SERVICE BULLETIN No. 9

SUBJECT: Elevator Control Cable Attachments.

REFERENCE: Service Letter No. 55

AIRCRAFT AFFECTED: All Maule Models.

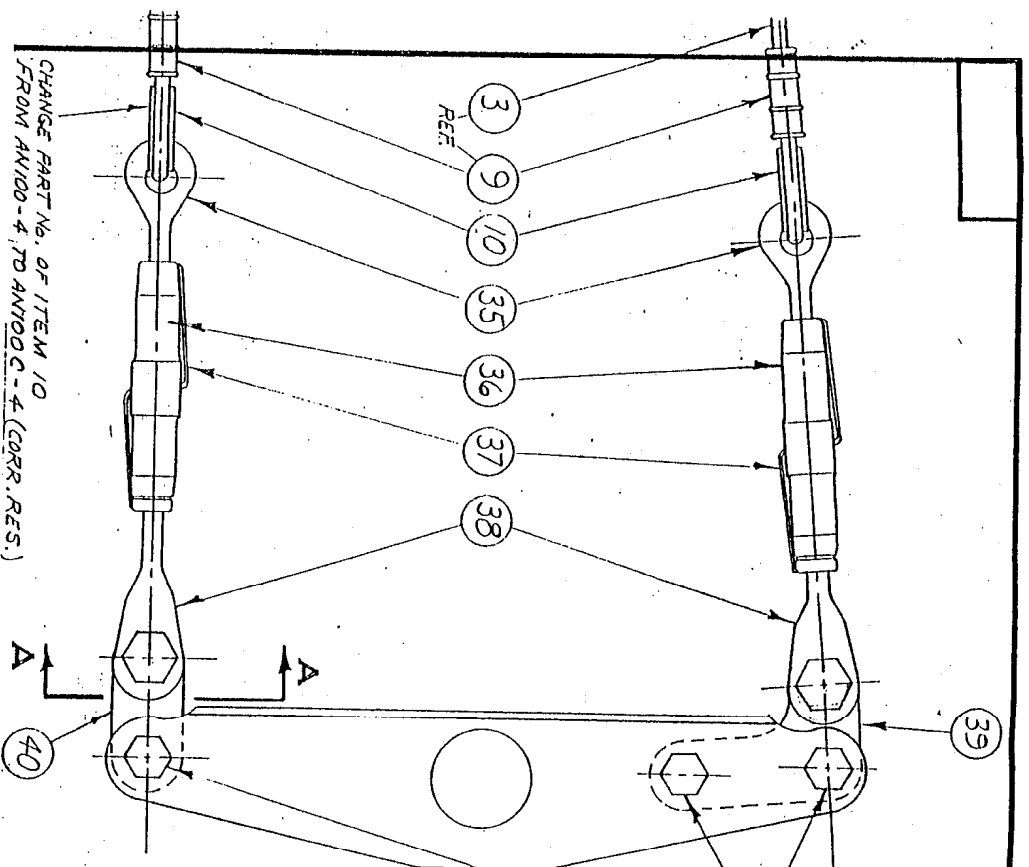
All operators of Maule airplanes are requested to remove the fuselage inspection covers above and below the elevators and visually check the pivoting action at the control cable attachment points over the **FULL** range of elevator travel. This action should be such that there are no bending loads imparted to the turnbuckles (which are designed for straight tension load only). Any binding which causes bending of the turnbuckles should be removed. Any cable attachment parts which display appreciable corrosion must be replaced before further flight. Pivot points must be cleaned and lubricated with any lightweight lubricating oil. Following lubrication, the cable attachments, including the turnbuckles, must be heavily coated with a good preservative such as:

MAULE
 MOULTRIE
 AEROSPACE TECHNOLOGY, INC.
 GEORGIA
 SERVICE BULLETIN No. 9, Pg. 2 of 3

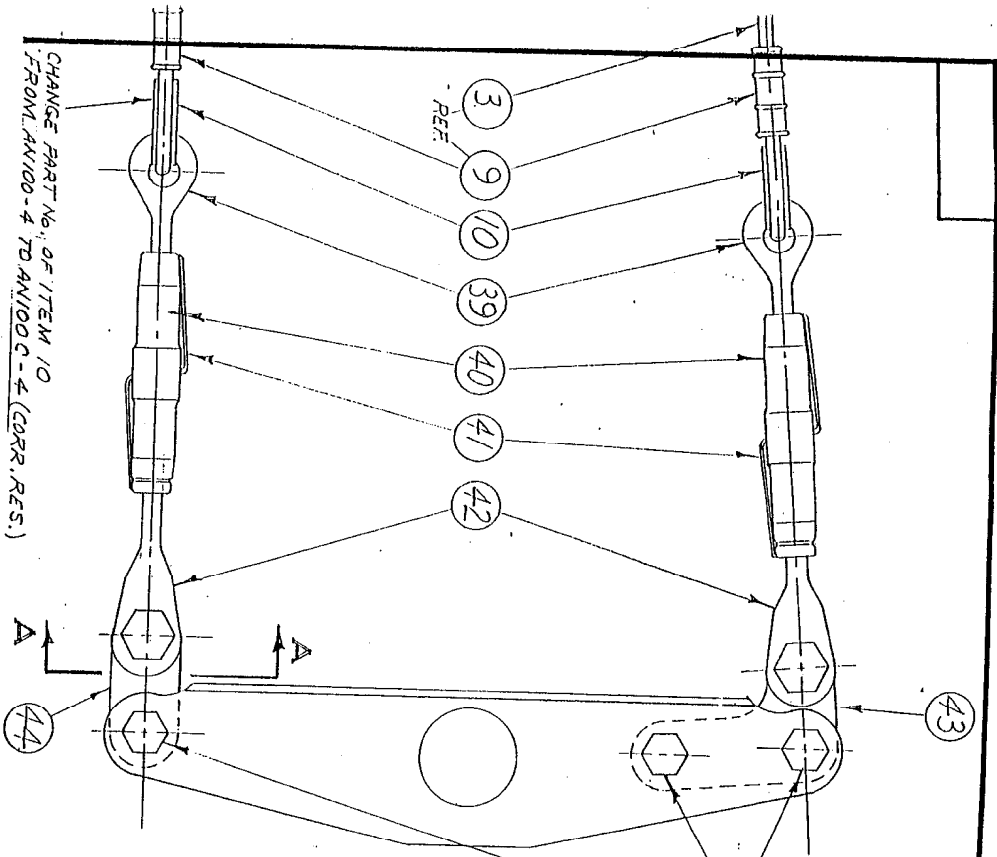
CHANGE PART No. OF ITEM 10 FROM AN100-4 TO AN100C-4 (CORR. RES.)

NOTES:
 1) INSTALL BOLTS, NUTS, AND WASHERS AS SHOWN.
 2) NO SUBSTITUTION FOR CORROSION RESISTANT PARTS.
 3) COAT ALL CABLE ATTACHMENT PARTS AND LINKS WITH PARAL-KETONE, LPS 3, OR EQUIVALENT.

TIGHTEN FINGERTIGHT THEN BACK OFF ONE OR TWO COTTER PIN SLOTS AND INSTALL COTTER PIN. JOINT MUST ROTATE FREELY.

TORQUE TO SPEC. S-18

MAULE AEROSPACE TECHNOLOGY INC.
MOULTRIE GEORGIA
SERVICE BULLETIN No. 9, Pg. 3 of 3

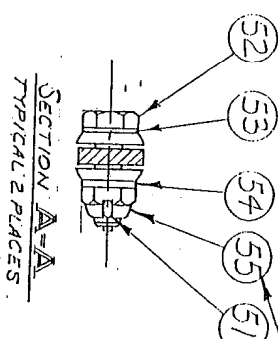
NOTES:
1) INSTALL BOLTS, NUTS, AND WASHERS AS SHOWN.
2) NO SUBSTITUTION FOR CORROSION RESISTANT PARTS.
3) COAT ALL CABLE ATTACHMENT PARTS AND LINKS WITH PARAL-KETONE, LPS 3, OR EQUIVALENT.

TIGHTEN FINGERTIGHT, THEN BACK OFF ONE OR TWO COTTER PIN SLOTS AND INSTALL COTTER PIN. JOINT MUST ROTATE FREELY.

TORQUE TO SPEC. 5-18
48 49 47 50 51
